Liquid Stone Concrete - CSP

Item for approval:

Site Plan (22-165)

➤ IH-35 Building Design (a)

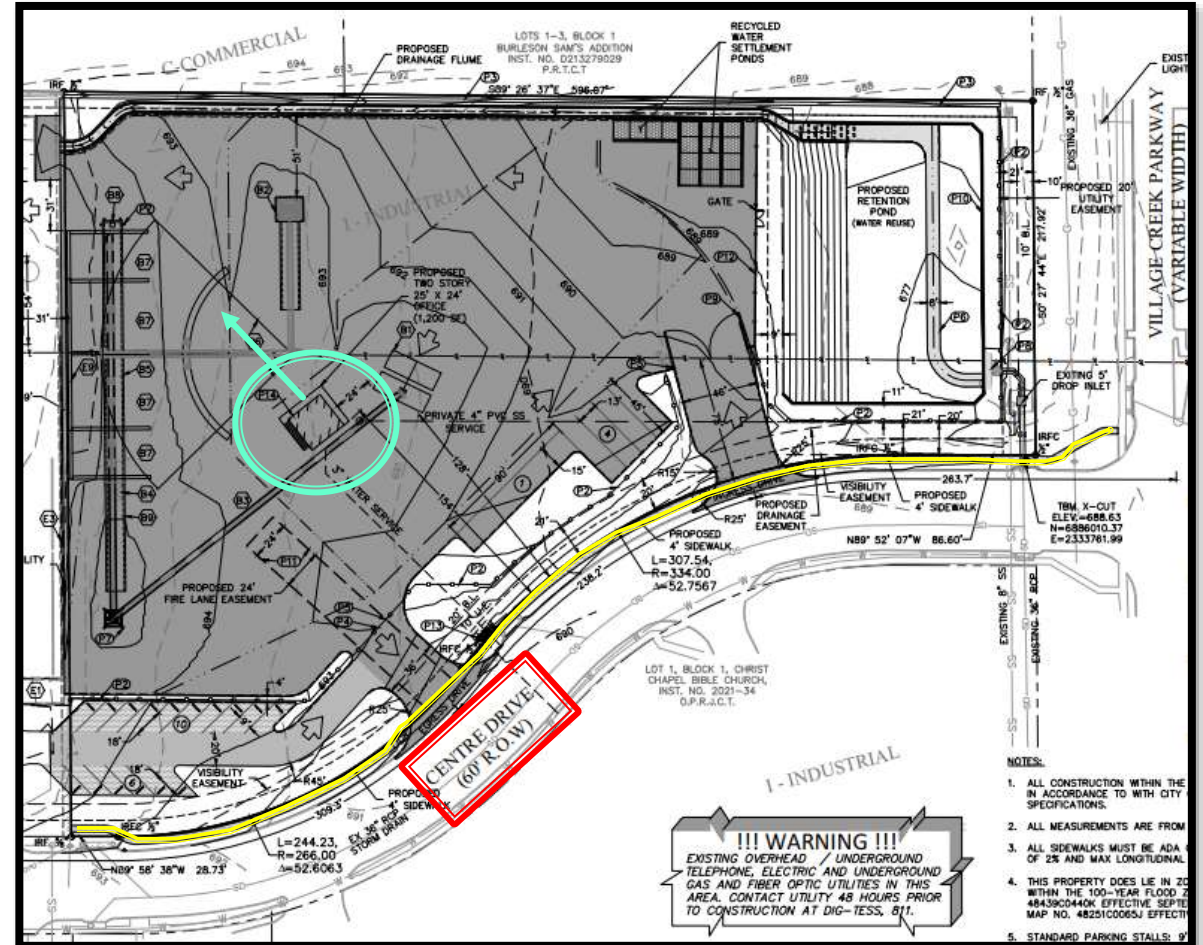
<p><u>Required:</u></p>	<p>One primary entryway shall face the principal street and connect directly to a sidewalk along the principal street.</p>
<p><u>Provided:</u></p>	<p>Primary entryway will not face towards nor connect to principal street. Sidewalk will be constructed along principal street.</p>
<p><u>Justification:</u></p>	<p>Primary use of the site is industrial. The main building / site are not intended for public use and will be screened accordingly</p>

04 SOUTH ELEVATION

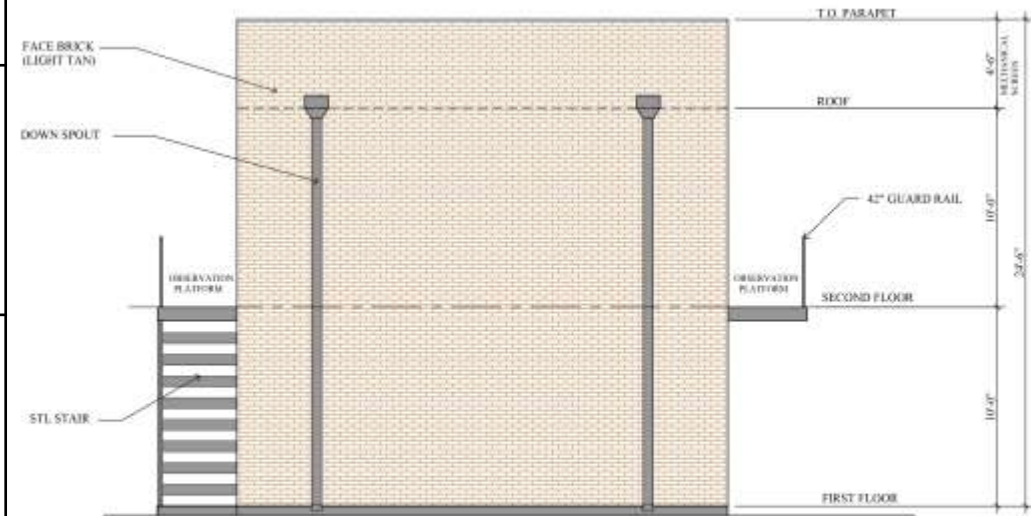
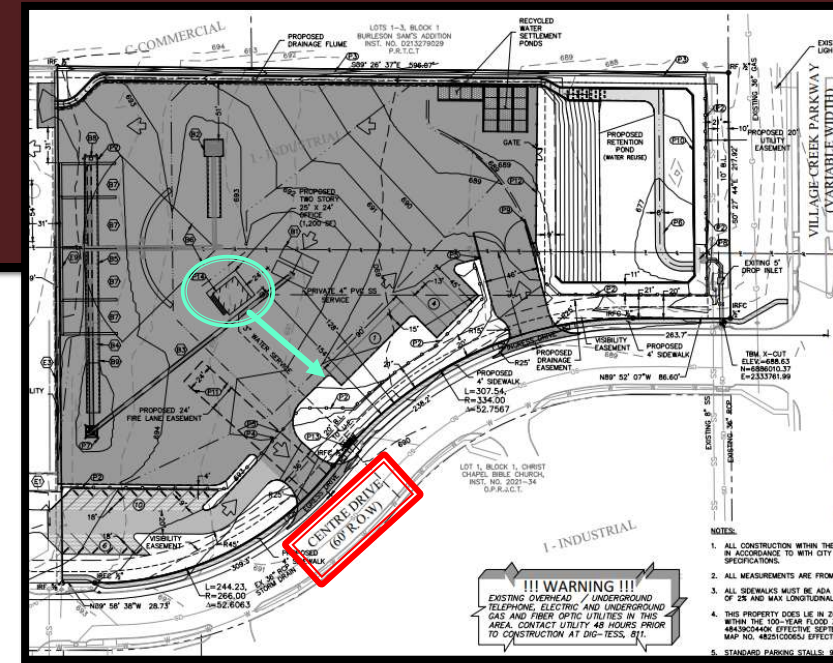
<p><u>Required:</u></p>	<p>On the building façade facing the principal street, at least 35 percent of the wall area on the first floor shall consist of windows or similar glazing</p>
<p><u>Provided:</u></p>	<p>South façade facing the principal street does not provide any glazing.</p> <ul style="list-style-type: none"> • North elevation: 15% • East elevation: 13%
<p><u>Justification:</u></p>	<p>Building is designed as a control area for the plant with specific views to the equipment and trucks. Windows are intended for observation of strategic operations and safety requirements.</p>

03 EAST ELEVATION
14' x 14'

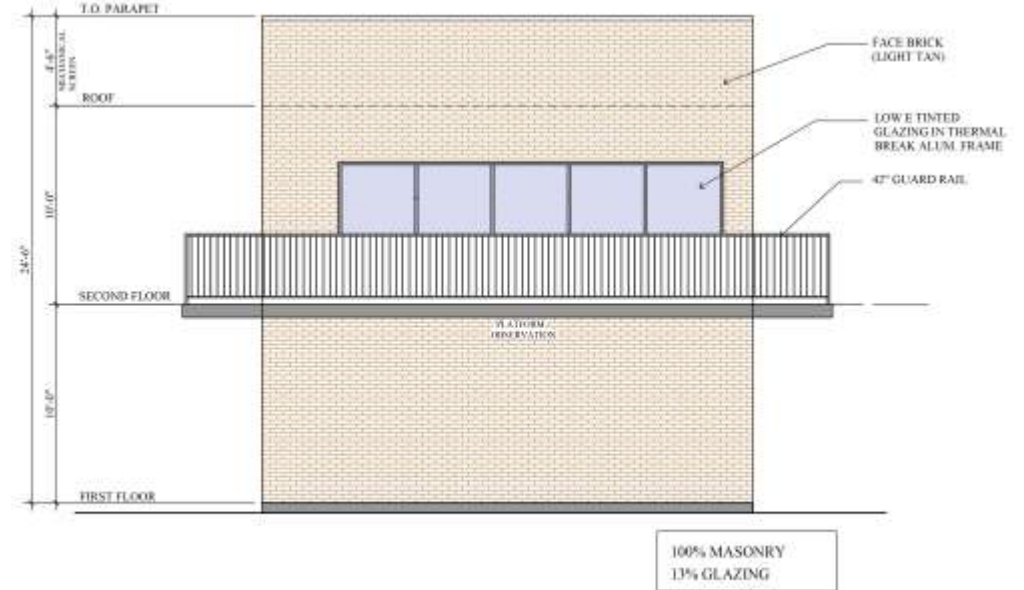
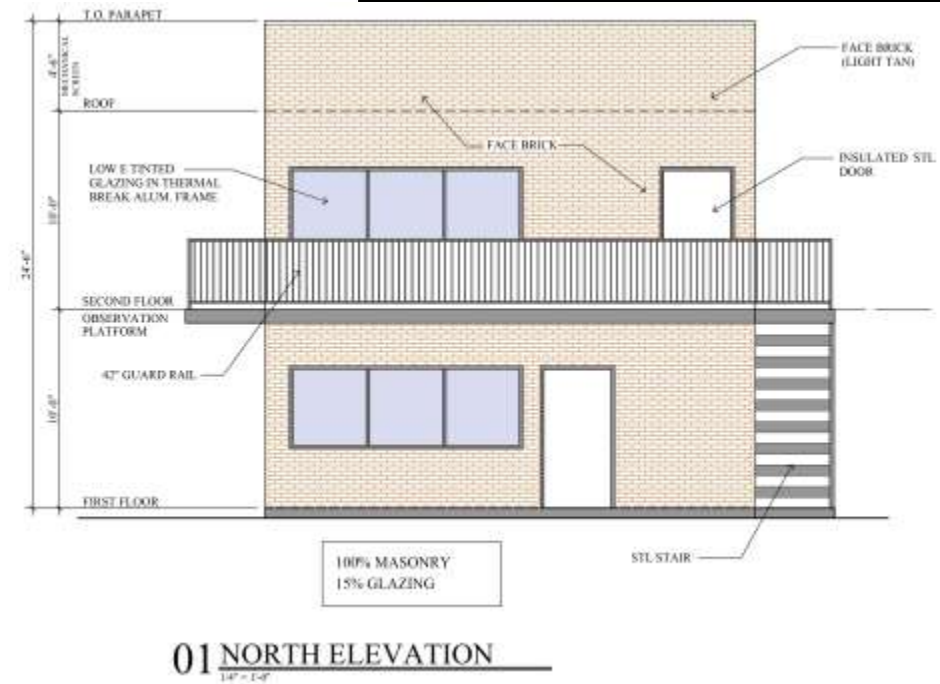
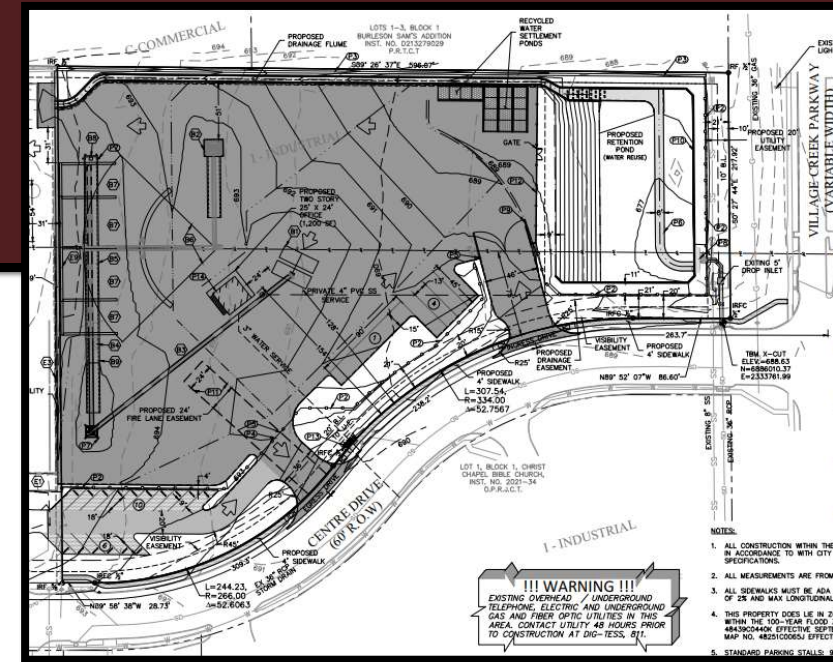
<u>Required:</u>	On all other publicly visible façades, at least 20 percent of the wall area shall consist of windows or similar glazing.
<u>Provided:</u>	Other publically visible façade to the east provides 13% glazing <ul style="list-style-type: none"> • North elevation: 15%
<u>Justification:</u>	Building is designed as a control area for the plant with specific views to the equipment and trucks. Windows are intended for observation of strategic operations and safety requirements.

➤ IH-35 Screening (a)

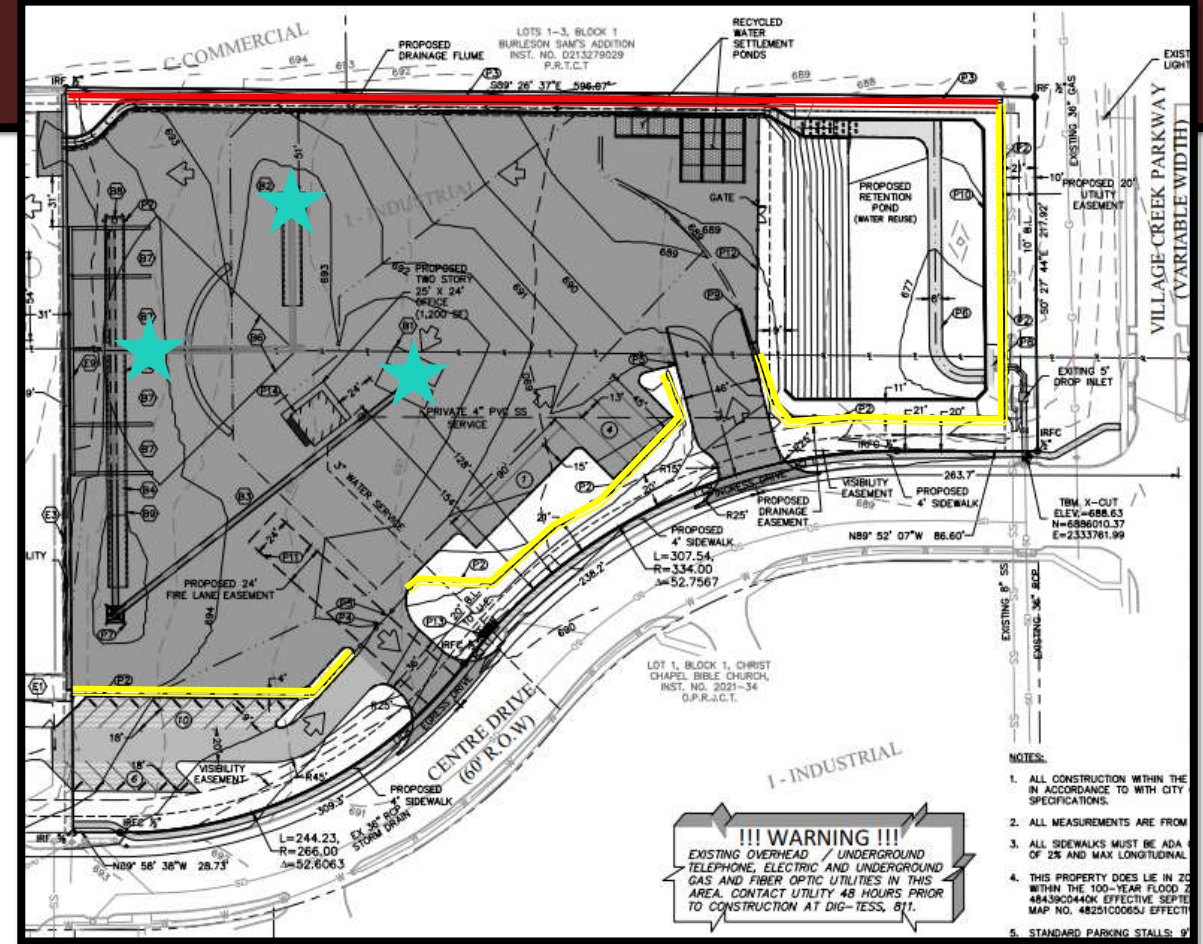
<p><u>Required:</u></p>	<p>Mechanical equipment and other support elements for buildings shall be screened from view of any person standing on the property line.</p>
<p><u>Provided:</u></p>	<ul style="list-style-type: none"> • 8' masonry wall along the south and east (principal) sides of the property • 12' masonry wall along the north (rear) property boundary.
<p><u>Justification:</u></p>	<p>Screening the equipment entirely cannot be achieved due to the height of batching equipment = 42 – 85 feet</p>

The northern property line is the only property line that does not meet the 50' buffer requirement so a 12' masonry fence was proposed.
